STAFF REPORT: OCTOBER 9, 2024, REGULAR MEETING
APPLICATION NUMBER: HDC2024-00569
ADDRESS: 1180 VINEWOOD
HISTORIC DISTRICT: HUBBARD FARMS
APPLICANT: VALERIA LOPEZ
PROPERTY OWNER: VALERIA LOPEZ
DATE OF PROVISIONALLY COMPLETE APPLICATION: SEPTEMBER 19, 2024
DATE OF STAFF SITE VISIT: SEPTEMBER 26, 2024

SCOPE: ALTER DWELLING INCLUDING WINDOW AND DOOR OPENINGS, ROOF, SIDING, AND PORCH (WORK COMPLETED WITHOUT APPROVAL)

West (left) and north (right) elevations of work from March 23, 2024, application, largely completed without approval. This application received a Denial.

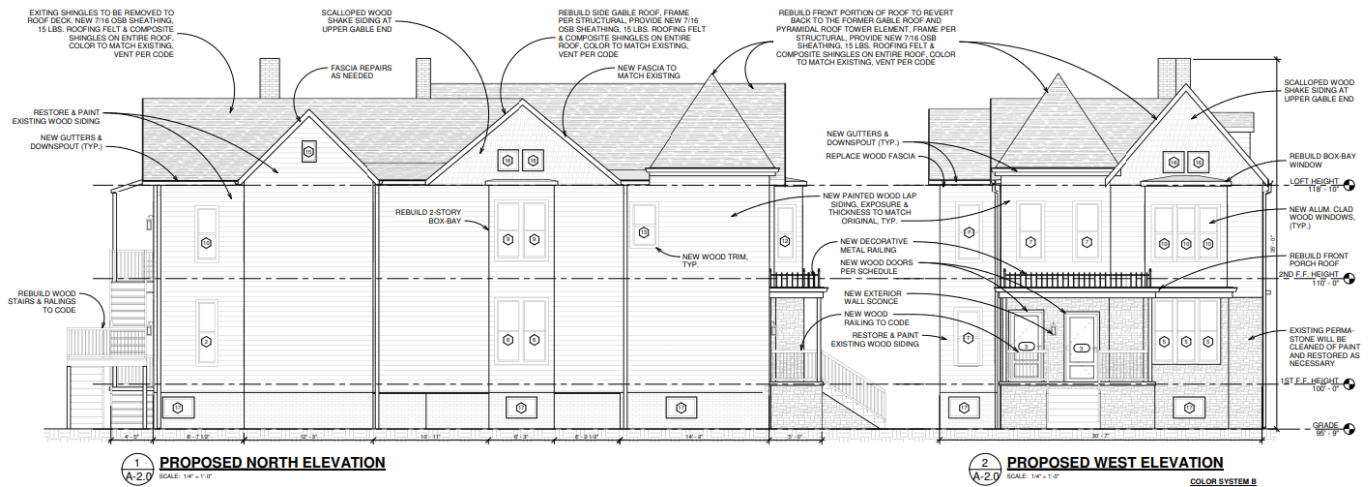
At its April 10, 2024, meeting, the Commission issued a Denial for the proposed (largely already completed) work, citing the following reasons:

- The proposed work removes distinctive and character-defining features from the building (such features must be preserved; if beyond repair, they may be replaced with matching new features). These features include the front porch, decorative trim on bay windows, wood siding, and wood scalloped shingles.

- The proposed work alters historic features and spaces by fundamentally changing the form of the building. Inappropriate spatial alterations include reducing the height of the building, converting the historic roof form with tower, front gable, side gable, and side dormer to a gable roof, increasing the footprint of the building on the north wall, adding a gable top to the west-facing bay window, converting the north-facing bay window from two stories to one, and altering the fenestration pattern.
- The proposed work adds an incompatible new front porch to the building.
- The proposed work adds historically inappropriate vinyl materials to the building

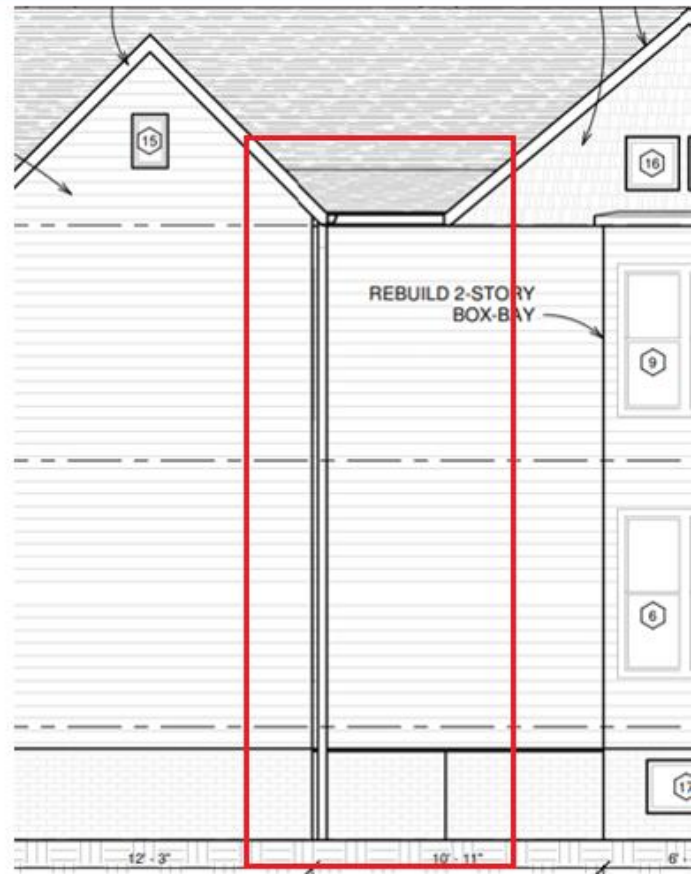
- The alteration of the roof shape is, in staff opinion, the most severe and inappropriate component of the prior work completed without approval. The work was contrary to Standard #2, which requires that “the alteration of features and spaces that characterize a property shall be avoided.”
- This current proposal substantially reconfigures the roof form to restore its prior geometry and appearance, replacing the lost tower, front gable, side gable, and side dormer. Although exact measurements of the lost roof features are not available (the features were destroyed without having been documented), the proposed work appears to closely match the prior appearance of the roof shape, based on available photos.

- Two box-bay windows were also inappropriately altered by the prior work, adding a gable top to the west-facing bay window and converting the north-facing bay window from two stories to one. The proposed work also remedies this condition, returning those elements as closely as possible (again, exact measurements are not available) to its pre-violation condition.

Recessed area between gabled bays on side (west) of building, indicated by red boxes added by staff. Left: historic condition (Google Maps 2023); Right: proposed work (from application drawings, cropped by staff).

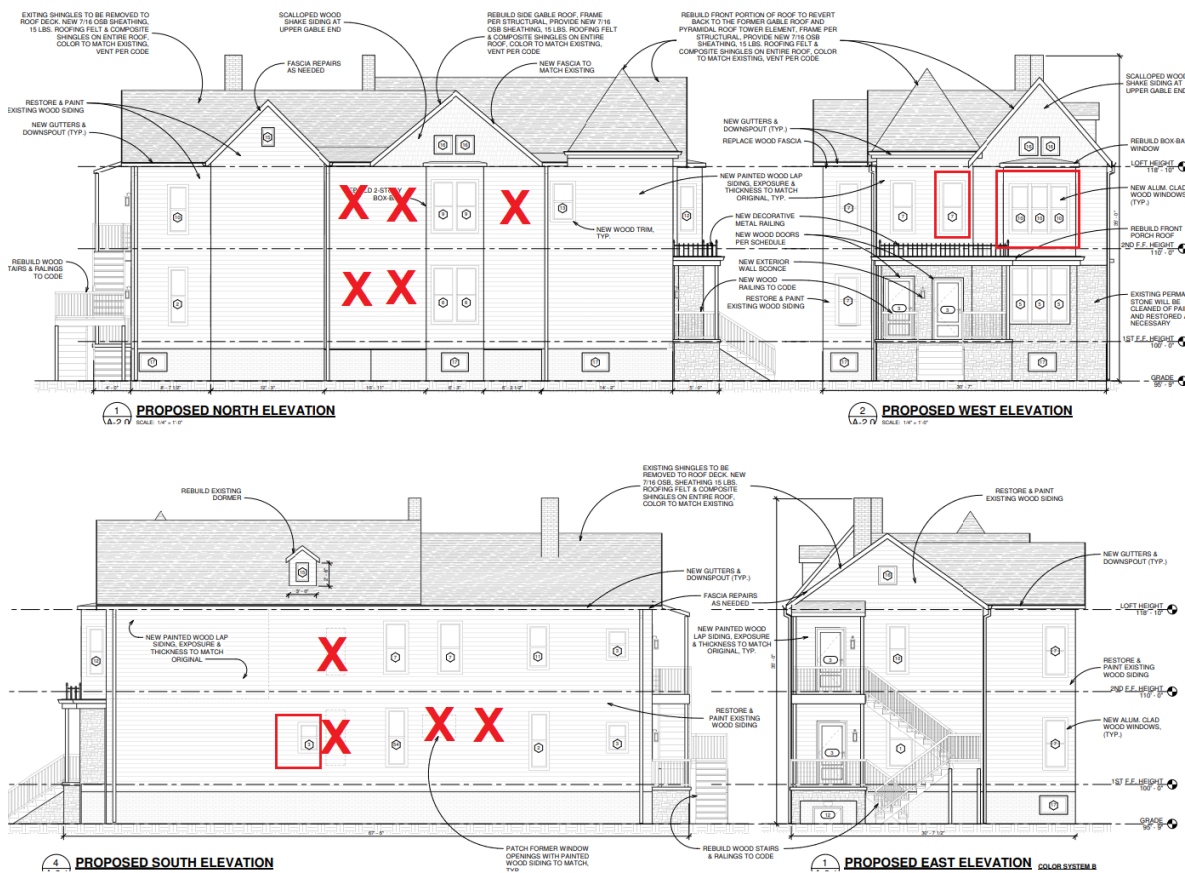
- The prior, unapproved work changed the overall footprint of the building by the elimination of a recessed, central portion of the north wall.
- The proposed work does not restore this feature to the pre-violation condition, and would therefore allow an unapproved “alteration to features and spaces that characterize the property,” per Standard #2, to persist. The application narrative states:

- Staff suggests that the “cumulative effect” guidance quoted on page 8 may apply to this feature, as its contribution to the historic character of the building is minimal.

- Additional window openings shall be added to the north elevation, subject to staff approval.
- The three windows on the second floor, west (front) elevation, box-bay shall be increased in height to match the historic condition, subject to staff approval.
- The selection of scalloped shingles shall be subject to staff approval.

Elevation drawings from application, marked in red by staff. X represents prior window openings proposed for elimination. Boxes indicate prior window openings proposed to be resized.

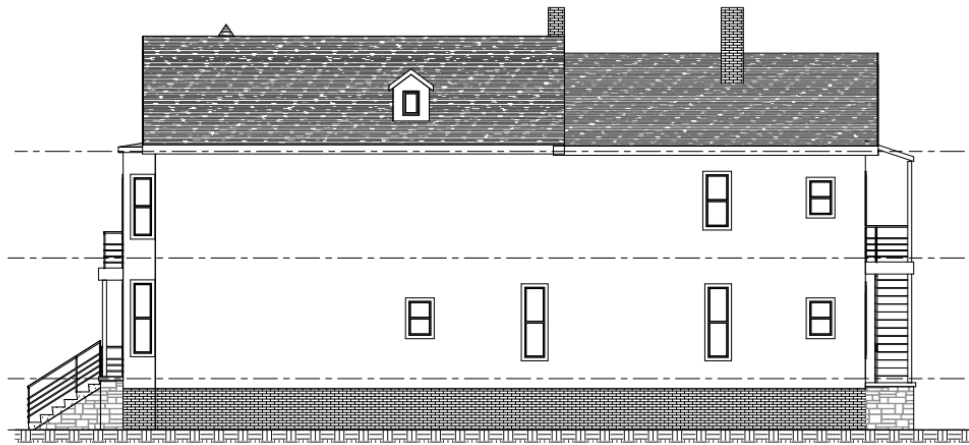
- Staff’s ability to determine the appropriateness of the proposed placement of window openings is hindered by a lack of historical documentation, especially on the side and rear elevations, which were not captured in 1993 designation photos or in prior HDC application documents. In more recent photos, the openings are boarded up and fire damaged. However, staff provides the following observations:

- The prior placement of openings on the north (side) elevation may not reflect the condition during the period of significance. 2023 (pre-violation) Google Maps photos show seven openings on the westernmost gabled bay, but no openings at all on the easternmost gabled bay. This arrangement would be unusual in a 1900-era building. More likely, some of the openings were door openings reflecting the mid-twentieth-century conversion of the building to apartments; other openings may have been closed over time.

- The historical arrangement of openings on the south (side) elevation is not known. However, the application documents associated with the 2018 COA depict fewer window openings than today. Of note, the windows proposed for elimination in the current application are not shown in the 2018 drawings, suggesting that *either* those windows did not exist historically, *or* the Commission, at the time, considered them not to be important, character-defining features requiring preservation.

- Based on the above observations indicating that the window openings are not known to be historic, character-defining features, and the applicant’s statement that the window openings facilitate adapting the building to its new occupancy, staff suggests that, in general, the proposed reconfiguration of the window openings on the side elevations is appropriate, with some exceptions (see “Issues,” below).

- However, staff also believes that the overall reduction in the number of window openings creates expanses of blank wall that are not compatible with the character of the building or the district, contrary to Standard #9: “exterior alterations ... shall be compatible with the massing, size, scale, and architectural features to protect the historic integrity of the property and its environment” (again, see “Issues,” below).
